**DEPARTMENT OF THE NAVY
NAVAL AIR SYSTEMS COMMAND
RADM WILLIAM A MOFFETT BUILDING
47123 BUSE ROAD, BLDG 2272
PATUXENT RIVER, MD 20670-1547**

Cognizant Code: PMA260/AIR-6.7.6.2
Issue Date: 10 March 2010

SUPPORT EQUIPMENT CHANGE NO. 5824 (TD CODE 62)

SUBJECT: UPGRADE OF MOBILE FACILITY ECU COOLING CABLE CIRCUIT TO 40 AMPS TO ACCOMMODATE R134A ECU PN 1559AS400-1, (WUC GEC60)

Figure 1 – Thermostat Bracket Modifications

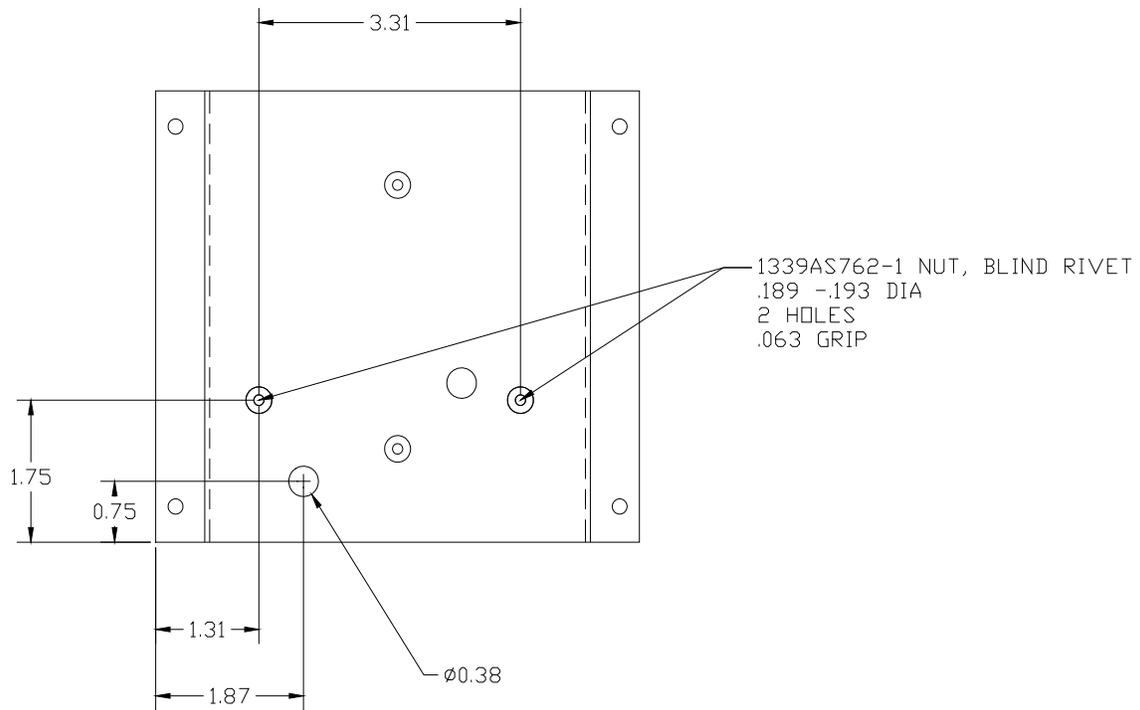
- Discard removed thermostat, thermostat cable and thermostat guard that was previously attached to the R-22 ECU.
- (16) While thermostat bracket is removed, install two new rivnuts, PN 1339AS762-1 (S6-75) IAW Enclosure (1), Figure 1, using a C845-632 blind rivet installation tool.

- (17) Drill new thermostat cable clearance hole in the thermostat bracket IAW Enclosure (1), Figure 1.
 - (18) Reinstall modified thermostat bracket IAW Reference (c), WP 019 00 para. 008.

- (17) While thermostat bracket is removed, install two new rivnuts, PN 1339AS762-1 (S6-75), IAW Enclosure (1), Figure 1 using a C845-632 blind rivet installation tool.

- (18) Drill new thermostat cable clearance hole in the thermostat bracket IAW Enclosure (1), Figure 1.
- (19) Reinstall modified thermostat bracket IAW Reference (c), WP 019 00 para. 8.

- (14) Remove existing thermostat and thermostat bracket IAW Reference (c), WP 019 00 para. 8.
- (15) While thermostat bracket is removed install two new rivnuts, PN 1339AS762-1 (S6-75) IAW Enclosure (1), Figure 1 using a C845-632 blind rivet installation tool.

- (16) Drill new thermostat cable clearance hole in the thermostat bracket IAW Enclosure (1), Figure 1
- (17) Reinstall modified thermostat bracket and thermostat IAW Reference (c), WP 019 00 para. 34 step c.

Figure 2
Connection Diagram ECU Cooling Cable Front Panel
40 Amp Circuit Breaker

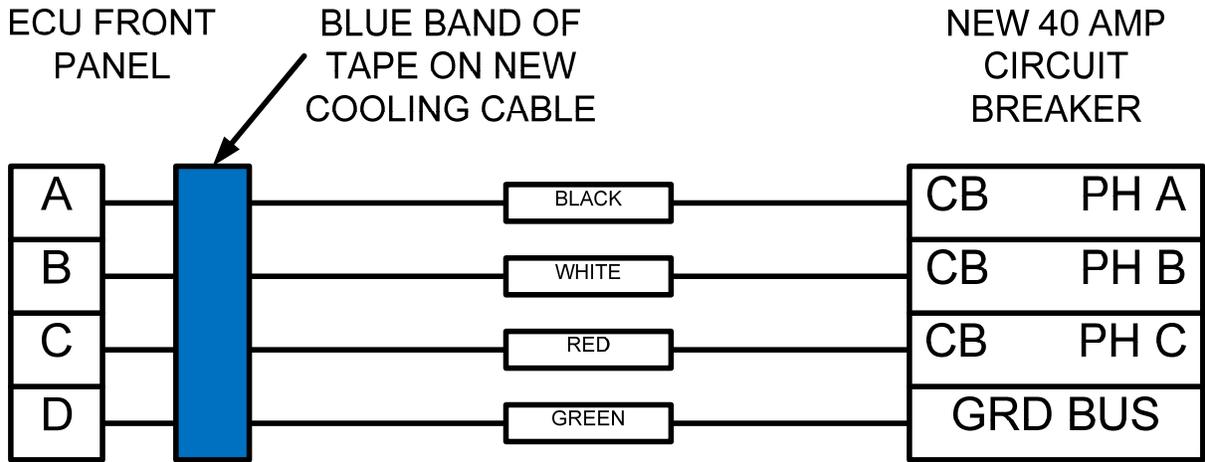
- (14) Install new cooling cable 1339AS1231-1 in place of the removed cable PN 1339AS883-1 using the same mounting hardware IAW the schematic in Enclosure (1), Figure 2.

- (10) Install new 40 amp ECU cooling circuit cable PN 1339AS1232-3 IAW Reference (c), WP 019 00 para. 37 using the 40 amp cooling circuit cable PN 1339AS1232-3 instead of the 30 amp cooling cable 1339AS867-3 IAW the schematic in Enclosure (1), Figure 2. The cable shall be routed through the raceway the same as the cable which was removed in step (2). Install new cable ties in any locations cable ties were removed in step (2).

- (15) Install new cooling cable 1339AS1231-1 in place of the removed cable PN 1339AS883-1 using the same mounting hardware IAW the schematic in Enclosure (1), Figure 2.

- (10) Install new 40 amp ECU cooling circuit cable PN 1339AS1232-1 IAW Reference (c), WP 019 00 para. 37 using the 40 amp cooling circuit cable PN 1339AS1232-1 instead of the 30 amp cooling cable 1339AS867-1 IAW the schematic in Enclosure (1), Figure 2. The cable shall be routed through the raceway the same as the cable which was removed in step (2). Install new cable ties in any locations cable ties were removed in step (2).

- (10) Install new 40 amp ECU cooling circuit cable PN 1339AS1232-3 IAW Reference (c), WP 019 00 para. 37 using the 40 amp cooling circuit cable PN 1339AS1232-3 instead of the 30 amp cooling cable 1339AS867-3 IAW the schematic in Enclosure (1), Figure 2. The cable shall be routed through the raceway the same as the cable which was removed in step (2). Install new cable ties in any locations cable ties were removed in step (2).

Figure 3
Connection Diagram ECU Cooling Cable Front Panel
ECU Terminal Board TB2

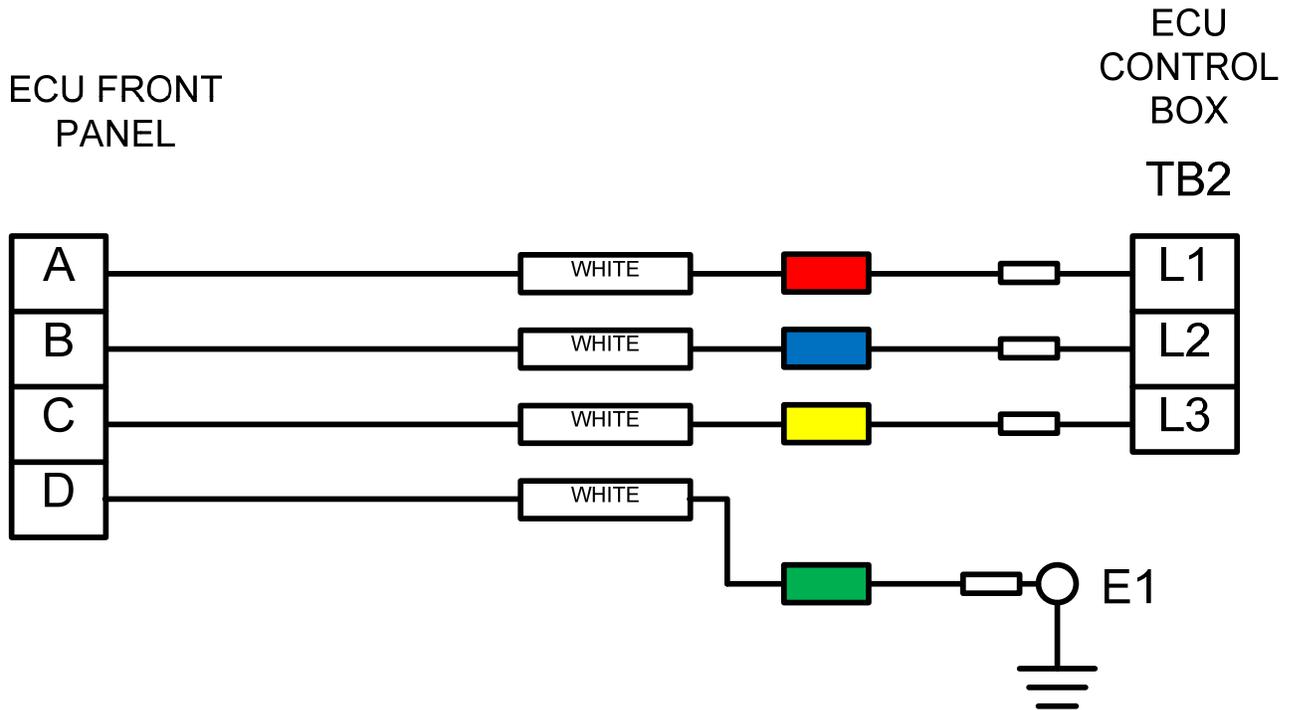
- (a) Connect the heat cable 1339AS882-1 to terminal board 1 in the ECU control box IAW the schematic in Enclosure (1), Figure 4.
 - (b) Connect the cool cable 1339AS1231-1 to terminal board 2 in the ECU control box IAW the schematic in Enclosure (1), Figure 3.

- (a) Connect the heat cable 1339AS882-1 to terminal board 1 in the ECU control box IAW the schematic in Enclosure (1), Figure 4.
 - (b) Connect the cool cable 1339AS1231-1 to terminal board 2 in the ECU control box IAW the schematic in Enclosure (1), Figure 3.
